Contract Number 8918	Contract Title I-5/I-205 to North Fork Lewis River Bridge - Rehabilitate Pavement	Federal Aid Number NHPP-0051(297)
Change Order Number 3	Change Description Additional Concrete Panels PT1	Date Dec 7, 2016
Region Southwest Region	Project Engineer Lori Figone	Phone Number 360-905-1501
Prime Contractor / Design-Builder Granite Construction Company

**WASHINGTON STATE
DEPARTMENT OF TRANSPORTATION
CHANGE ORDER**

I-5/I-205
TO NORTH FORK LEWIS RIVER BRIDGE
- REHABILITATE PAVEMENT
PAVING DETAILS

HMA TO PCCP MATCHING DETAIL

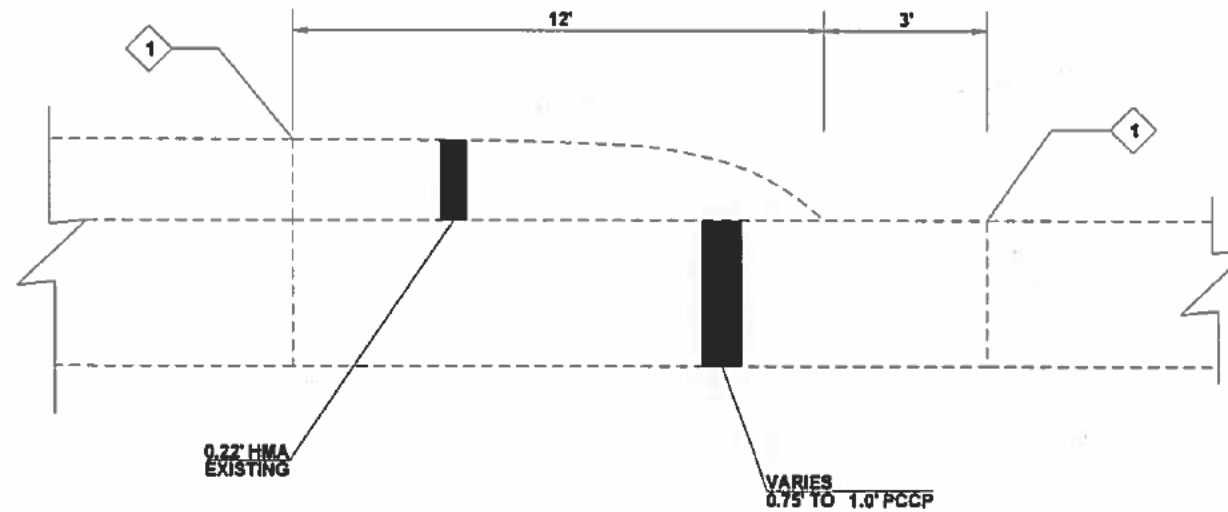
Add plan sheet PD1 (8A/22) to the Contract as shown on page 8 of this change order.

PCCP Panel MP 14.591 LN 1,2,3
NOT TO SCALE

Panel MP 14.591 LN 1,2,3
NOT TO SCALE

ADDITIONAL PANELS FOR REPLACEMENT

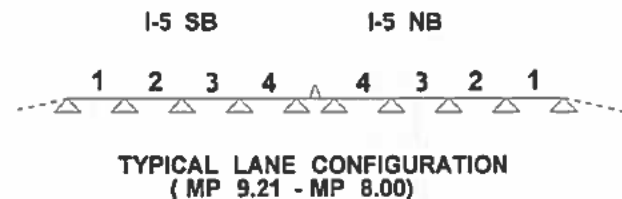
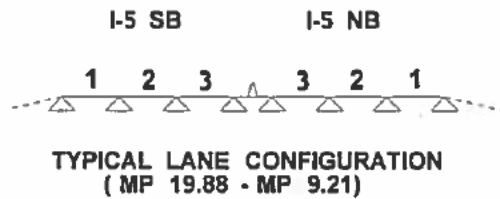
Add plan sheet PR3 (11A/22) to the Contract as shown on page 9 of this change order.

This change order adds additional cement concrete panels to be replaced to the Contract, as listed on plan sheet PR3 (11A/22)
